SUBJECT: Idler Gear Post

Units Affected: XP-1100

DEALER SERVICE MEMO NO. 301

SUBJECT: Piston Pin Retainers

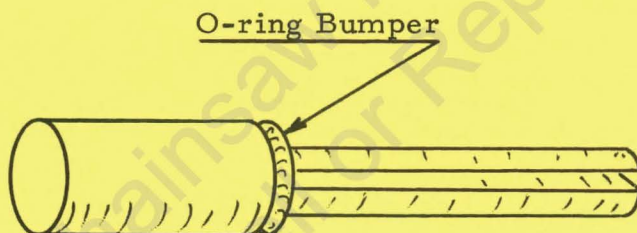
The method of retaining the piston pin on the exhaust side of the pistons for the units listed above has been changed.

A permanently installed Spirol Pin takes the place of the Snap ring on the exhaust side only. One snap ring (for the side opposite the exhaust) will still be supplied as part of each Piston and Pin Assembly.

New piston pin removers have been designed:

These tools are slotted to "straddle" the Spirol Pin.

Piston pins are installed with the closed end toward the Spirol pin side.

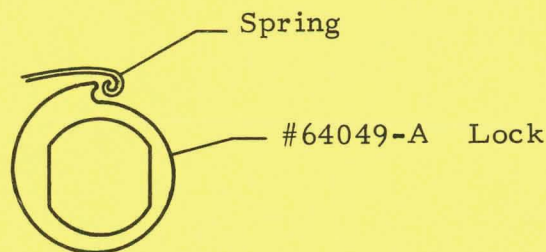
Now this job is made easy through the introduction of a separate spring lock for all XL's:

Instead of being cast as part of the magnesium pulley, the spring lock is made of sintered steel and registered around a washer on the pulley post before the pulley is installed - so that you can see what you are doing.

There are three new parts involved. As a group, they are completely interchangeable with the existing equipment. After you use up existing stock, use the new parts only:

New, separate, Steel Spring Lock	Part No. 64049-A
Register Washer (fits on post under lock)	Part No. 64400
Pulley <u>with</u> Cup (pressed in place)	Part No. A64446

To Assemble:

1. Slide washer #64400 onto the post.
2. Assemble the spring lock with its "hooked" nose right close to the inner loop on the spring as shown.
3. Then slide the starter pulley on the post and turn it clockwise only to engage the flats.

DO NOT TURN THE PULLEY COUNTERCLOCKWISE. By turning clockwise only you make sure that the spring stays hooked to the spring lock.
